Office Action Summary

10/671,842

BROOKSHIRE, MICHAEL D.

DETAILED ACTION

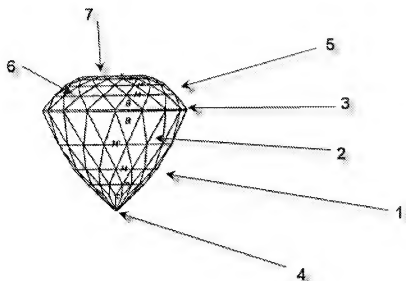
As for Claim 40, Diagrams for Faceting reference discloses of a cut gemstone (see figure 9), comprising:

a pavilion (1) having a plurality of facets (2) disposed from a girdle (3) to a culet (4); and
a dome-shaped crown (5) disposed above the girdle (3), wherein the girdle (3) extends no further than a widest circumference (bottom of 5) of the dome-shaped crown (5) and the pavilion (1) extends no further than a widest circumference of the girdle (3), the dome-shaped crown (5) formed from a plurality of sets of facets (6) cut with monotonically decreasing angles to form a curved contour in accordance with a dome shape from the girdle (3) to an apex (7) of the dome-shaped crown (5), each facet (6) within the sets of facets (6) being polygonal in shape with opposing corners of the polygon nested between adjacent facets (6).

Re: Claim 44, wherein the dome-shaped crown (5) is formed from at least five sets of facets (6) (see also figure ID on page 9 of "Diagrams") with monotonically decreasing angles to form the curved contour in accordance with the dome shape (5).

As for Claim 47, Diagrams for Faceting reference discloses of a cut gemstone (see figure below), comprising:

a pavilion (1) having a plurality of facets (2) disposed from a girdle (3) to a culet (4); and
a dome-shaped crown (5) disposed above the girdle (3), wherein the girdle (3) extends no further than a widest circumference (bottom of 5) of the dome-shaped crown (5) and the pavilion (1) extends no further than a widest circumference of the girdle (3), the dome-shaped crown (5) formed from a plurality of sets of facets (6) cut with monotonically decreasing angles to form a

curved contour in accordance with a dome shape from the girdle (3) to an apex (7) of the dome-shaped crown (5).

Re: Claim 48, wherein each facet (6) within the sets of facets (6) is polygonal in shape with opposing corners of the polygon nested between adjacent facets (6).

Re: Claim 54, wherein the dome-shaped crown (5) if formed from at least five sets of facets (6) (see also figure ID on page 9 of "Diagrams") with monotonically decreasing angles to form the curved contour in accordance with the dome shape (5).

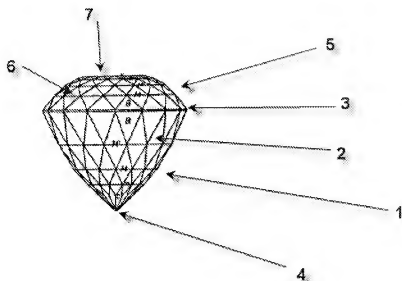
As for Claim 1, Diagrams for Faceting reference teaches of a diamond (see figure below), comprising:

a pavilion (1) having a plurality of facets (6) disposed from a girdle (3) to a culet (4), each of the plurality of facets (6) having a continuous flat surface extending from the girdle (3) to the culet (4), wherein an edge of a first adjoining facet contacts an edge of a second adjoining facet along a common radial boundary; and

a dome-shaped crown (5) disposed above the girdle (3), wherein the girdle (3) extends no further than a widest circumference (bottom of 5) of the dome-shaped crown (5) and the pavilion (1) extends no further than a widest circumference of the girdle (3), the dome-shaped crown (5) formed from at least five sets of facets (6) with monotonically decreasing angles to form a curved contour in accordance with a dome shape from the girdle (3) to an apex (7) of the dome-shaped crown (5), each facet (6) within the sets of facets (6) nested between adjacent facets (6), each of the sets of facets (6) having monotonically decreasing surface area from the girdle (3) to the apex (7) of the dome-shaped crown (5).

The difference between the claim and “Diagrams” is that “Diagrams” does not expressly disclose that each facet (6) within the set of facets (6) being hexagonal in shape. It would have been an obvious matter of design choice to modify “Diagrams” (the aspect of the shape of the facets within the sets of facets) since applicant has not disclosed that such a particular orientation creates any unexpected result. It appears that the invention would perform equally well as the invention disclosed by “Diagrams”. It is extremely old, well known, readily apparent and profoundly obvious to change the size, shape, number, orientation, angles, percentages, and create ranges for facets and the gemstone in its entirety as to merely alter the aesthetics of said gemstone for the corresponding and resulting properties including brilliance, radiance, etc. for the utility of mere user preference. It is also extremely well known that altering said features will produce different properties radiating from said gemstone, depending on the changes and

As for Claim 13, "Diagrams" teaches of a diamond (see figure above), comprising:

a pavilion (1) extending from a girdle (3) to a culet (4), wherein the girdle (3) extends no further than a widest circumference of the crown (5) and the pavilion (1) extends no further than a widest circumference of the girdle (3); and

a crown (5) in the form of a symmetrical hemisphere formed from at least five sets of facets (6) between the girdle (3) and an apex (7) of the crown (5) having a first set of facets (6) disposed above the girdle (3) and a second set of facets (6) disposed between the first set (6) of facets and an apex (7) of the crown (5), wherein the first set of facets (6) is cut at a first angle with respect to a reference line which is tangential to the apex (7) of the crown (5) and the second set of facets (6) is cut at a second angle with respect to the reference line which is less than the first angle, each facet (6) within the first and second sets of facets (6) being hexagonal in shape with opposing corners of the hexagon nested between adjacent facets (in view of remarks above).
